C2 - LAKEFRONT

GR. FLR SECTIONS.

19/2/19.
C2
Gr/floor (2)
sections.

19/2/19
C2 - Grd Flor Section

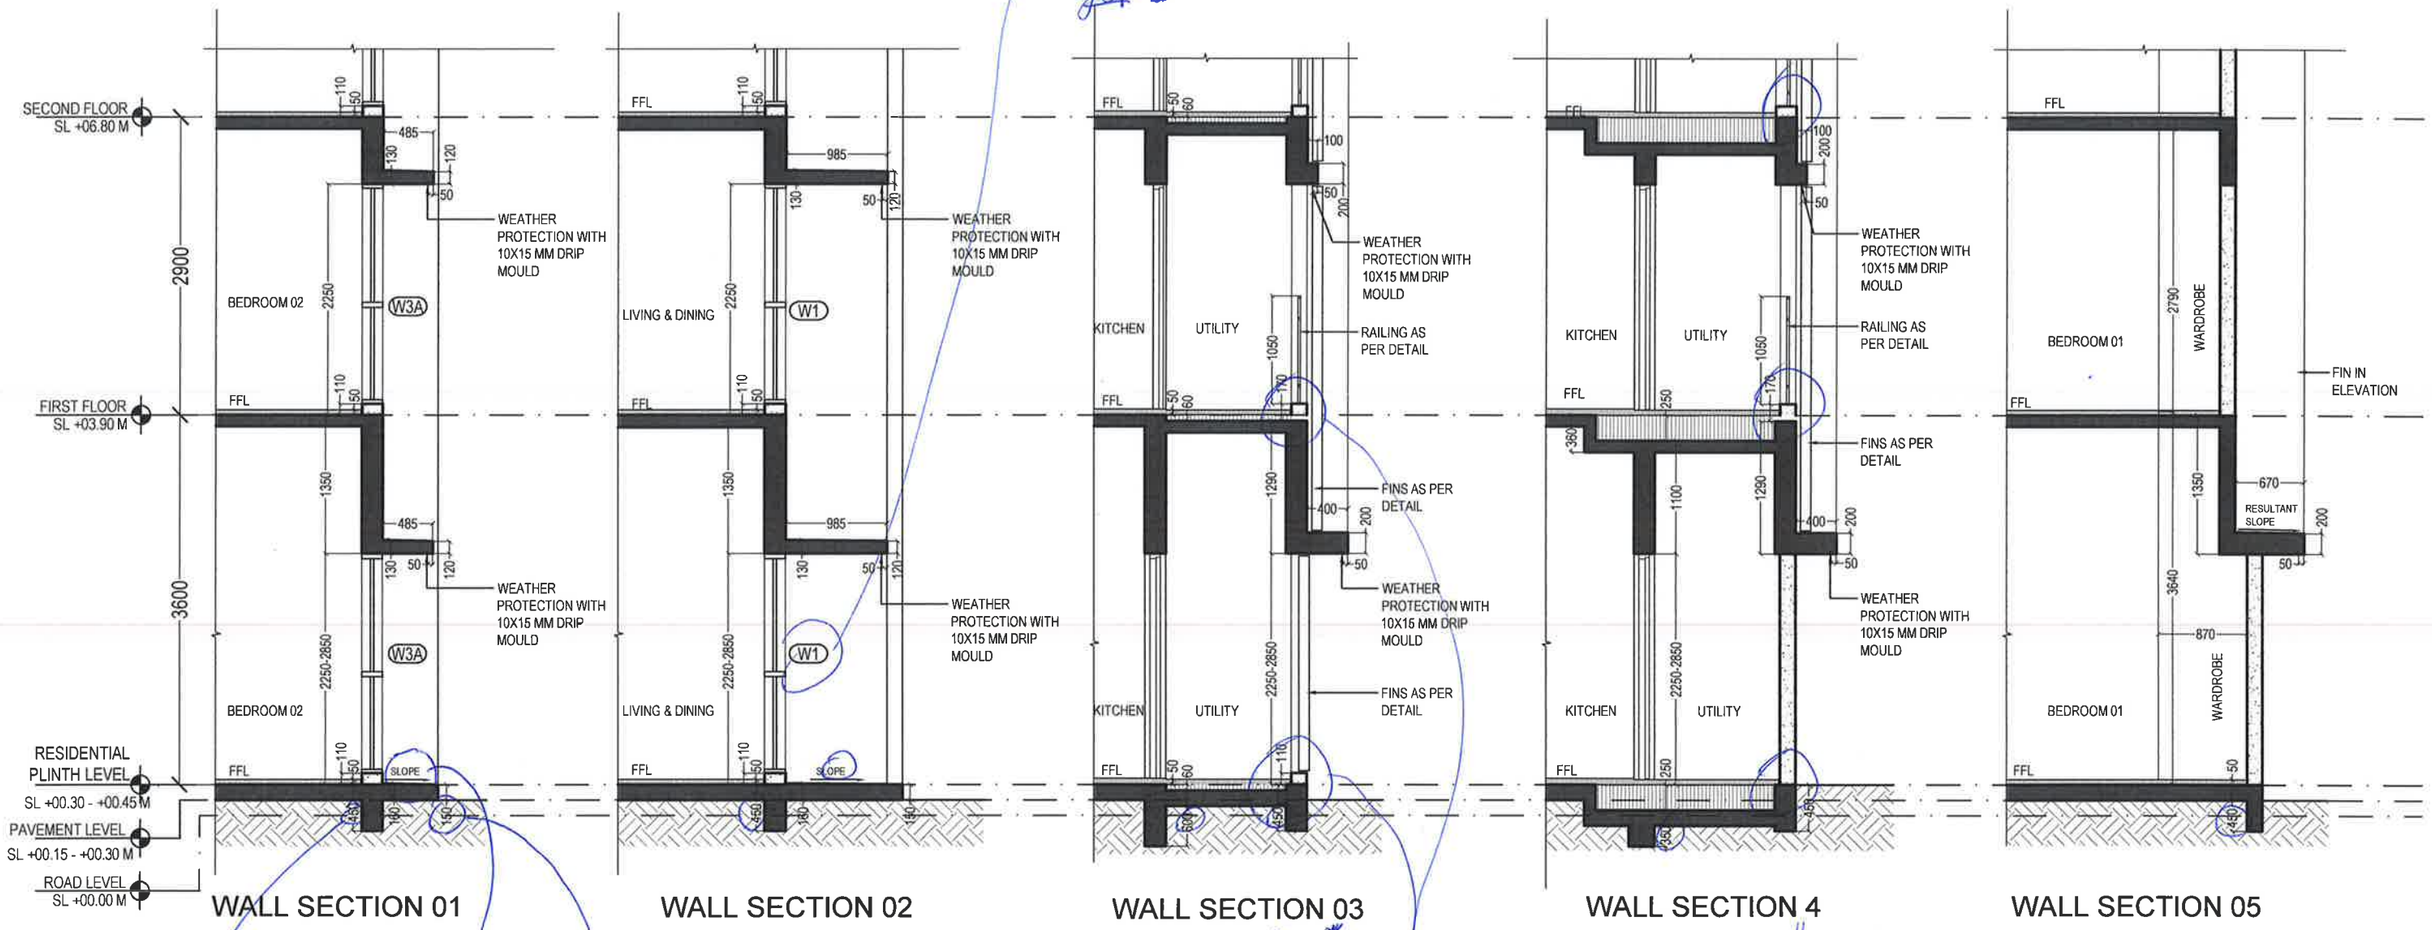
CHECK NOMENCLATURE OF ALL DOORS / WINDOWS.

WALL SECTION 05

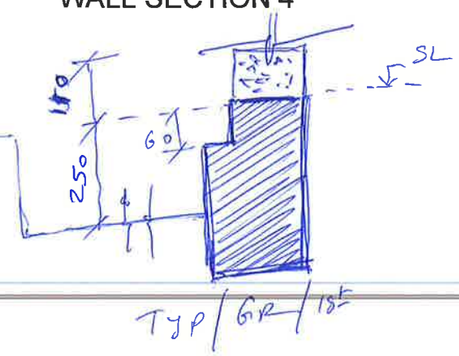
DONOT GIVE THE PLINTH BEAM DEPTH ANY WHERE.

SLOPE CAN BE ACHIEVED IN FINISHING. SLAB CAN BE STRAIGHT.

CHECK IN CASE THE OUTSIDE LEVEL HAS TO BE LIKE PVT. GARDEN (100 mm down) SECTION. ALTHOUGH NO ACCESS TO BE GIVEN.

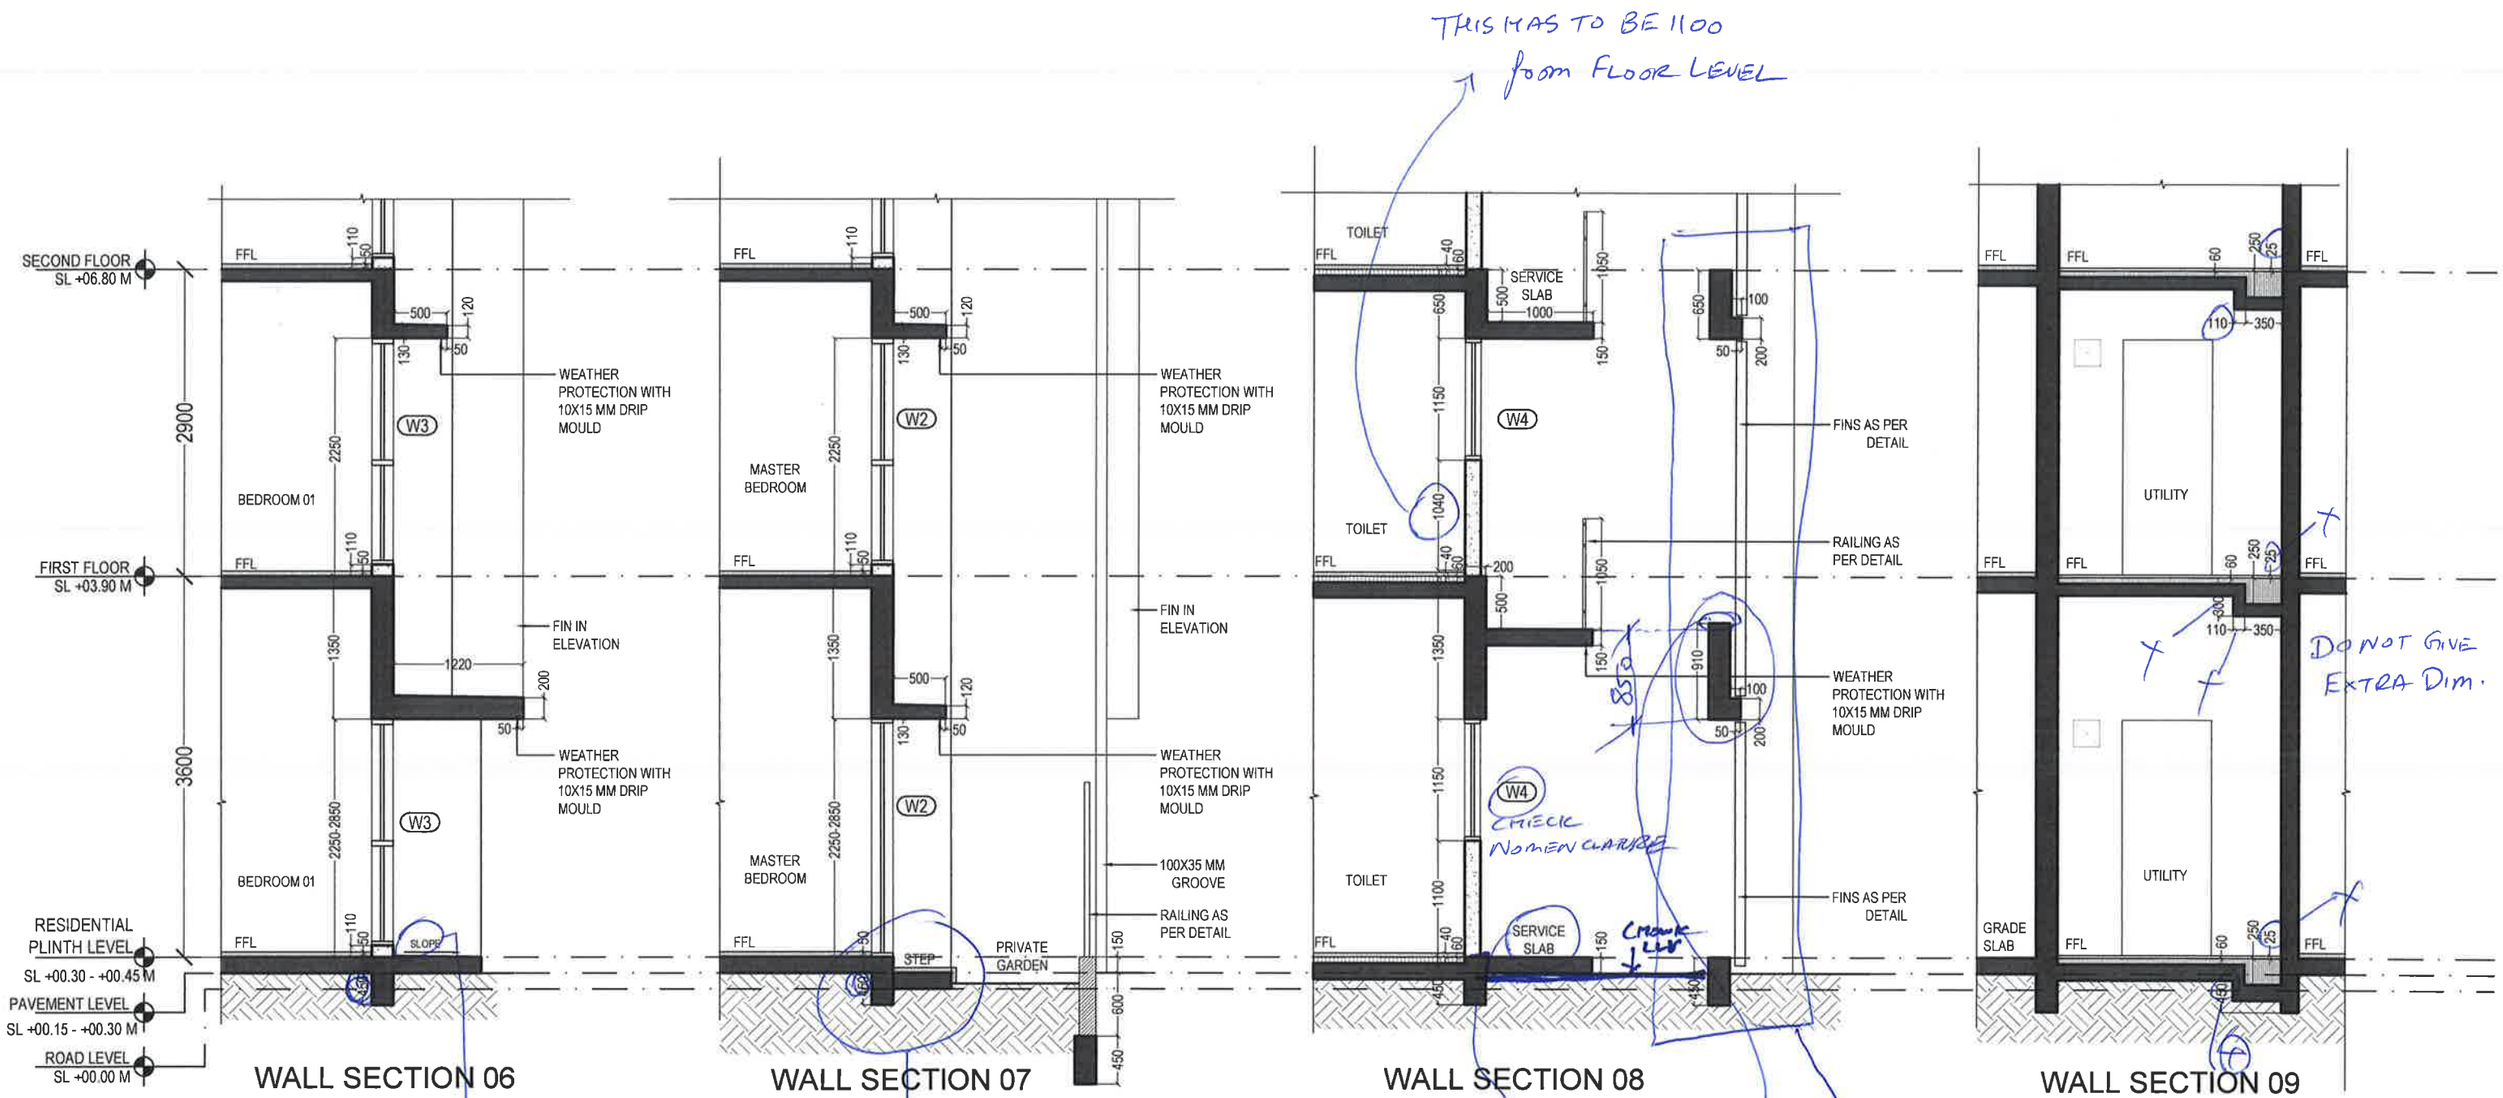
No Slope in slab Check Comments for Section 1.

Check the PVT. GARDEN STEP DETAIL in E typology. DIMENSIONS to be given.

DO NOT SHOW THIS SLAB AT GR. LVL. ~~STEP~~ MENTION CHAJJA level @ -150 from Bldg plinth.

BEAM TOP CAN MATCH WITH the Service slab top & DEPTH CAN BE 850

MENTION NOTE "ONLY AT OPEN ENDS OF THE CLUSTER"

CHECK WITH 'E' typolog

CHECK Dim.

Nomenclature Varandah

DRAINING OF WATER WILL BE AN ISSUE.

SBC HAS SHOWN THIS AS 120

THIS CAN BE VARYING BASED ON GROUND FLOR HT.

CHECK BEAM IN STRUC. PLAN

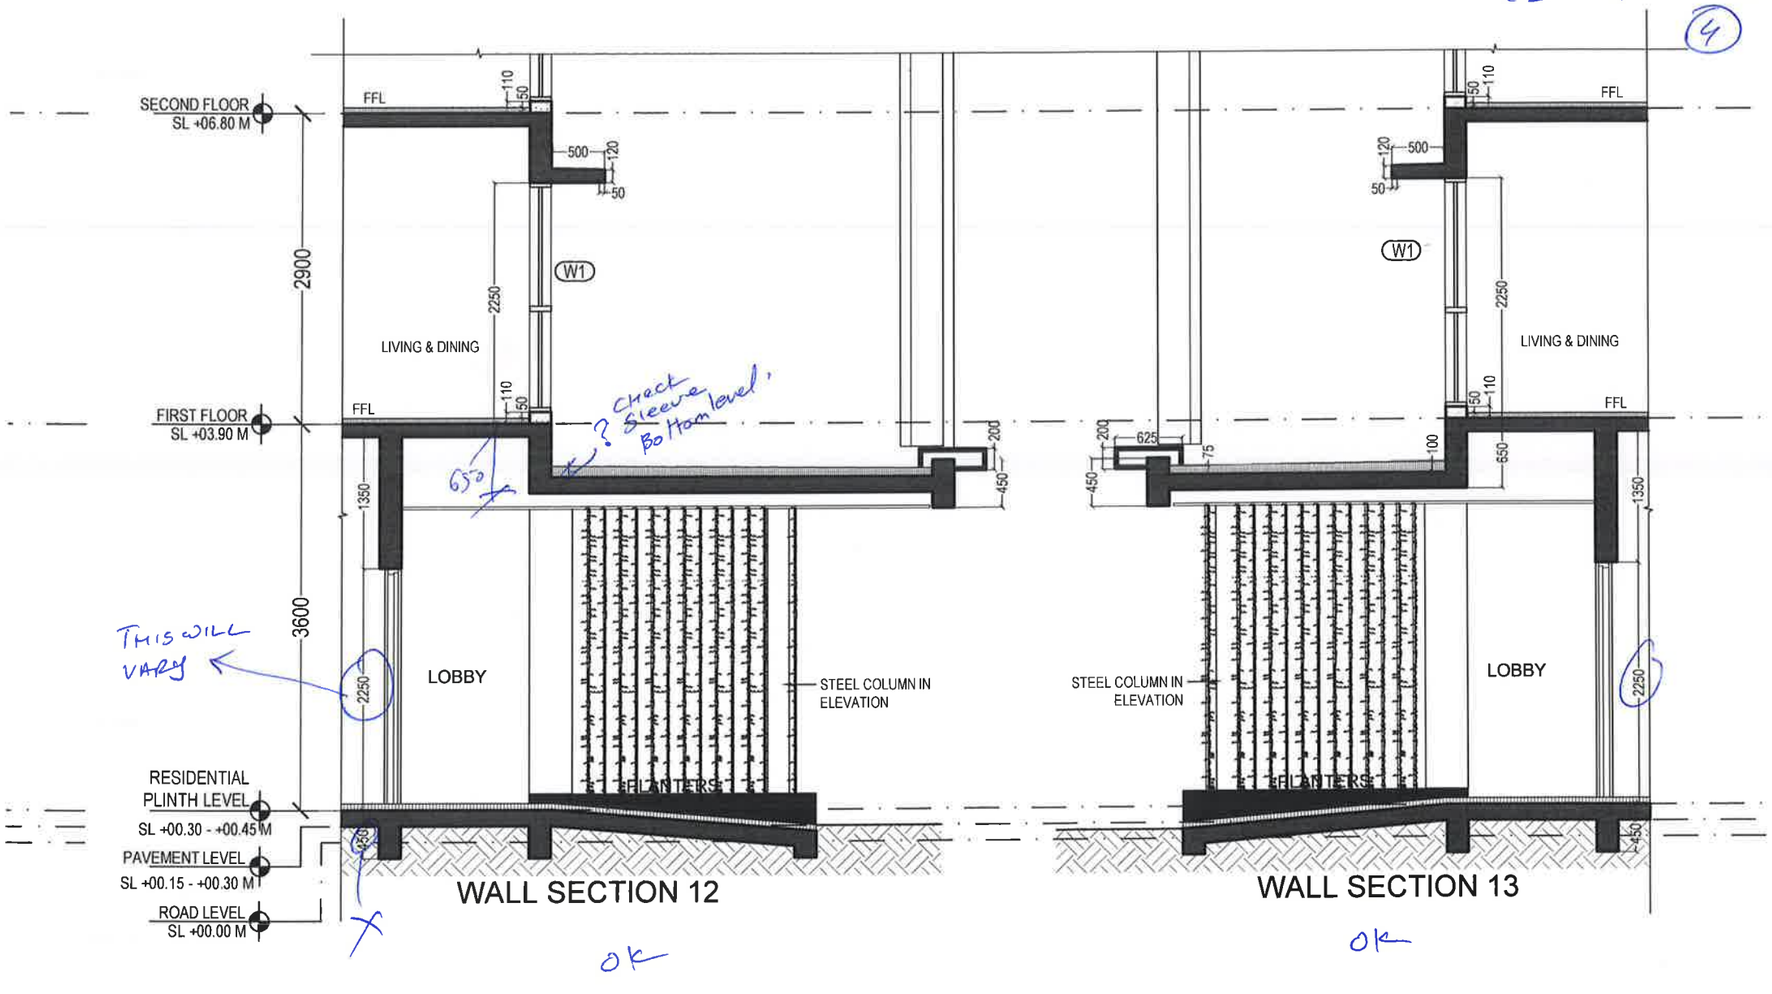
Give Dim

HAS TO BE 500.

WEATHER PROTECTION WITH 10X15 MM DRIP MOULD

500??

Give Dim

Give Dim

THIS WILL VARY
